Sent: 31/10/2019 10:32:49 AM
Subject: DA 2019/1122 - 50 Condoover Street, North Balgowlah
Attachments: 50 Condoover Street 311019.pdf;

Objection to DA 2019/1122 for proposed alterations and additions to an existing dwelling on Lot 4 in DP 30205 at 50 Condoover Street, North Balgowlah

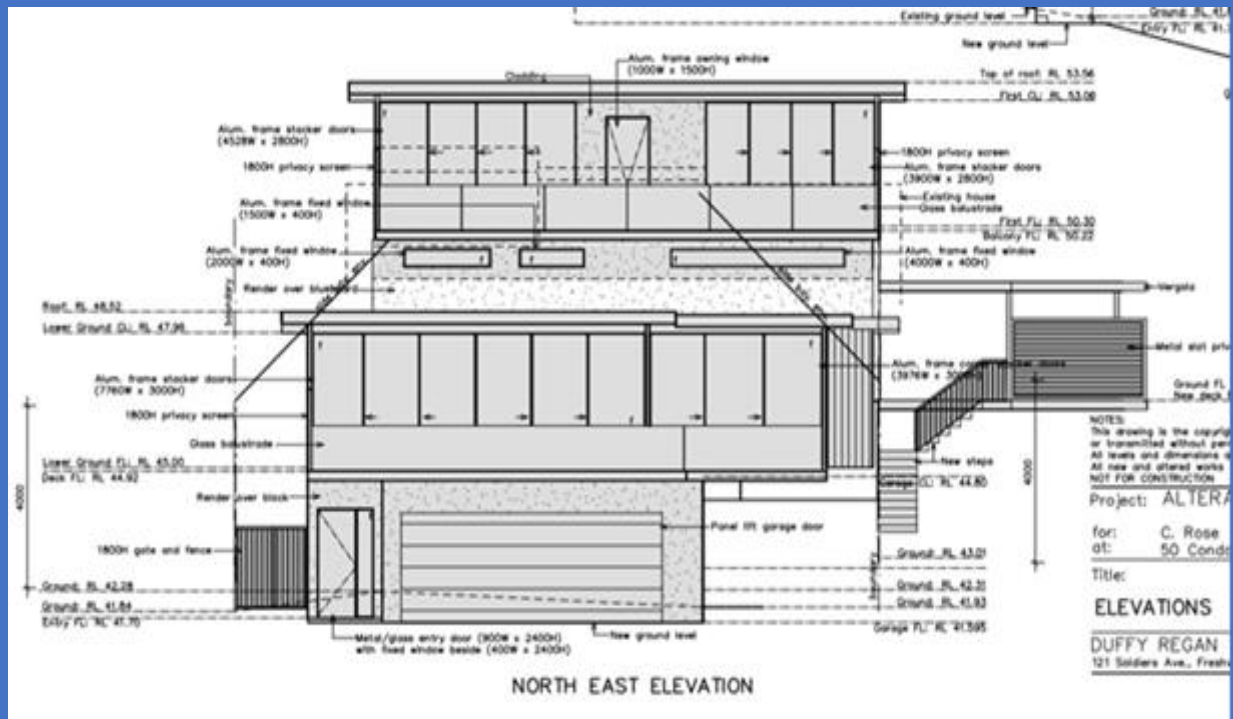
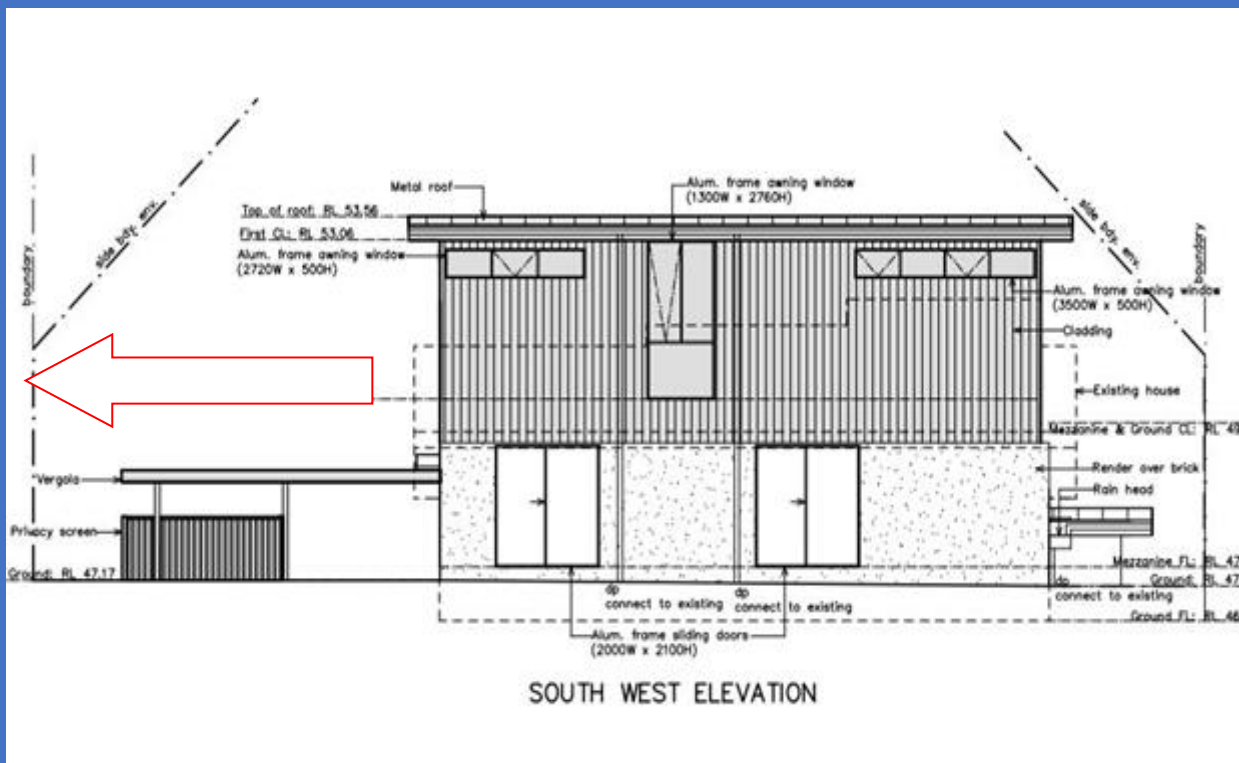
<p>Requirements</p> <p><i>1. Buildings on land shown coloured on the DCP Map Side Boundary Envelopes must be sited within a building envelope determined by projecting planes at 45 degrees from a height above ground level (existing) at the side boundaries of:</i></p> <ul style="list-style-type: none"> • <i>4 metres, or</i> • <i>5 metres as identified on the map</i> 	<p>The 4m control applies to this site and on the information provided it does not meet the stated objectives. There appears to be opportunity to relocate the building further north to ensure the bulk of the building sits within the envelope. Refer to the south west elevation.</p>	No

South East Elevation – View from No. 48 Condover Street –

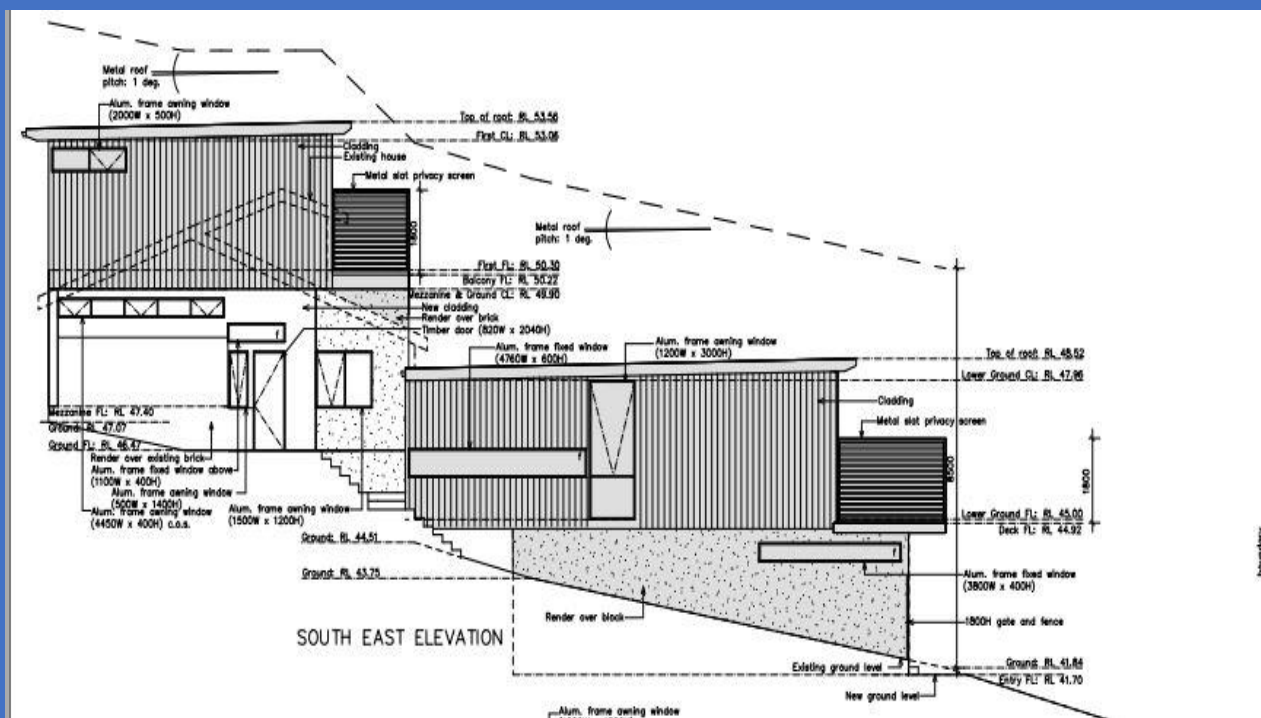
Northerly aspect views from No.48 Condover Street have been completely removed.

No sharing of views has been provided. The current bulk and scale of the design negates any opportunity for view sharing.

Existing northerly views from No. 48 Condoover Street across No.50 Condoover Street will be completely removed and replaced with built form.

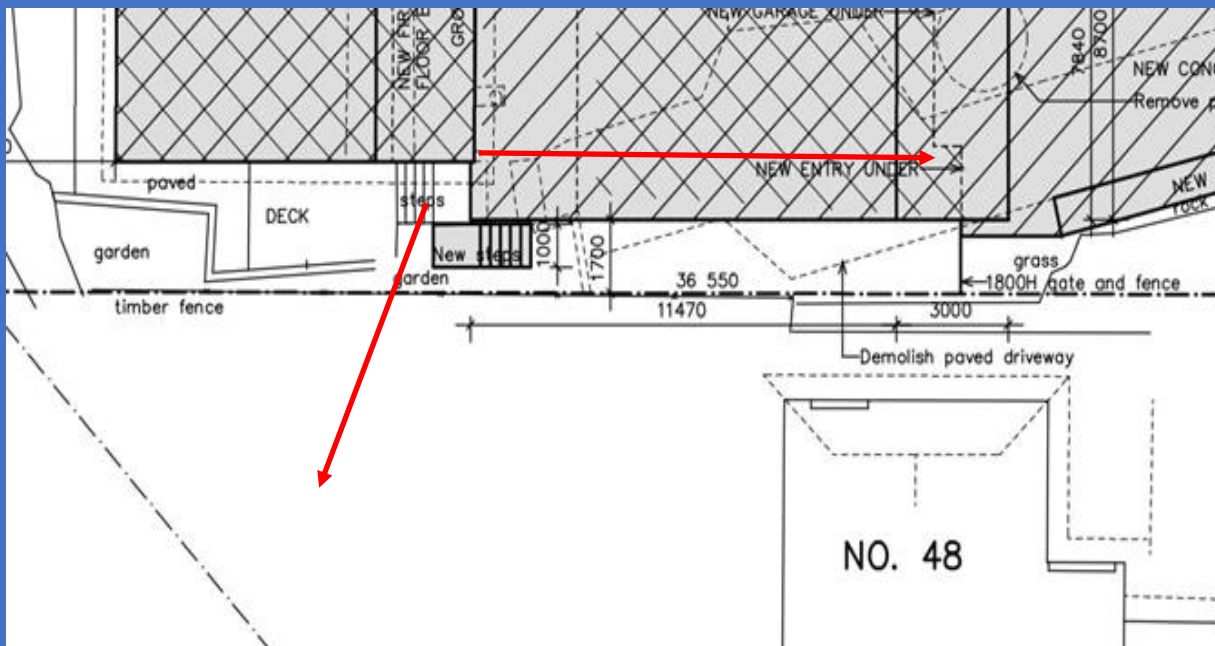
The primary outdoor entertaining area of No. 48 Condover Street will be overlooked by the provision of full-length windows, doors and access stairs.

While visual privacy screens have been provided, they do not account for the acoustic impact that will be generated.

The red horizontal arrow identifies the current set back and it is recommended that this set be retained, particularly at the second level in order to reduce overlooking and allow more sunlight into the rear of No.48 Condover.
